ONSITE SEWAGE DISPOSAL SYSTEM

PERMIT: REPAIR

PROPERTY ADDRESS: 13921 Wayside Drive

From: Wolf, Kevin
Sent: Friday, November 14, 2025 12:56 PM
To: 'Anna Schneider'
Cc: Young Septic Info
Subject: RE: 13921 Wayside Dr, Clarksville, MD 21029-Drawing

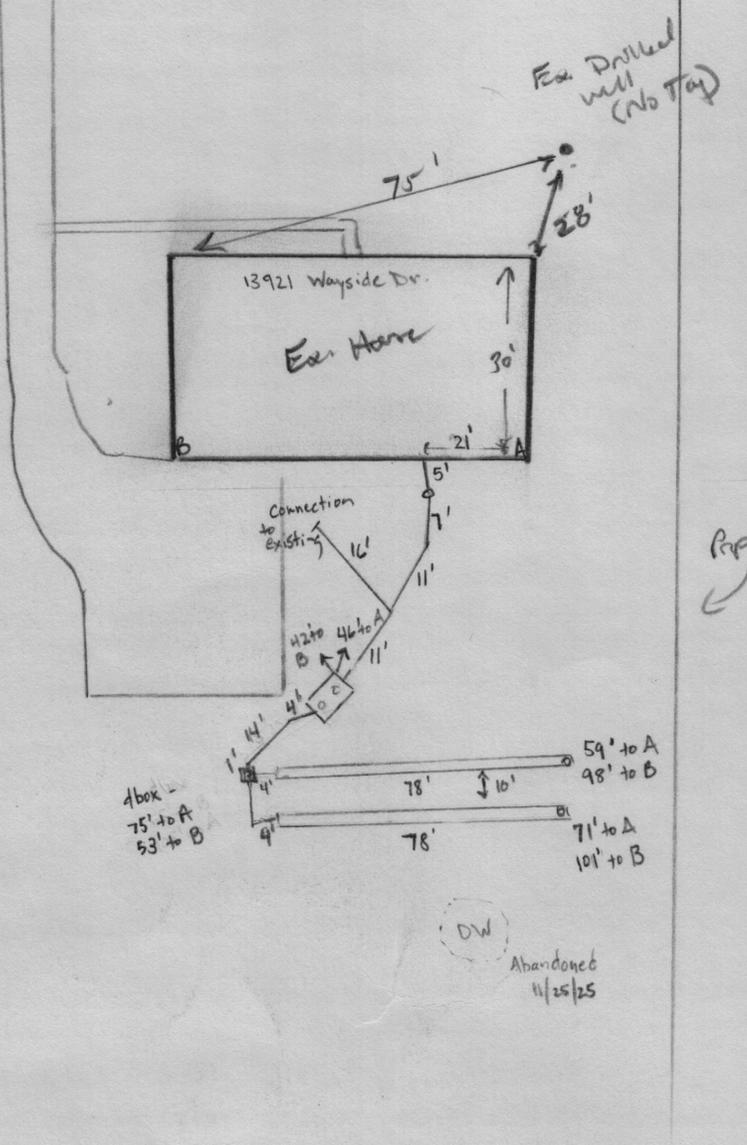
Comments that need to be addressed:

- Label lines as “existing property line staked by licensed surveyor”
- Must indicate the old back line to be removed and how. Elaborate on removing feet of old back line pipe thru proposed trenches.
- Must show and label all “existing” and “proposed” piping, including where new connection will take place
- Must show and label “proposed distribution box”, “proposed septic tank” and all plumbing.
- Must show observation pipes on trenches
- Must show manhole risers on new tank
- Must have proposed septic tank information (i.e. make, manufacture, size, etc.) on plan.
- Label “existing house”

For the information details section of the plan, must have the following:

- Need a Title (“septic system repair design plan”)
- Change “customer” as “Property Owner”
- Must have current bedroom count on plan
- You label Young septic as contractor but also need to say “contractor/plan preparer” with the persons name who prepared the plan (i.e. Matt Ward, Randy Young, etc.) → This is mainly due to the State law for the Board of Wastewater Professionals which requires an individual who prepares onsite septic system design plans to be licensed by the board.
<https://mde.maryland.gov/programs/water/BayRestorationFund/OnsiteDisposalSystems/Pages/WastewaterServiceProfessionals.aspx>
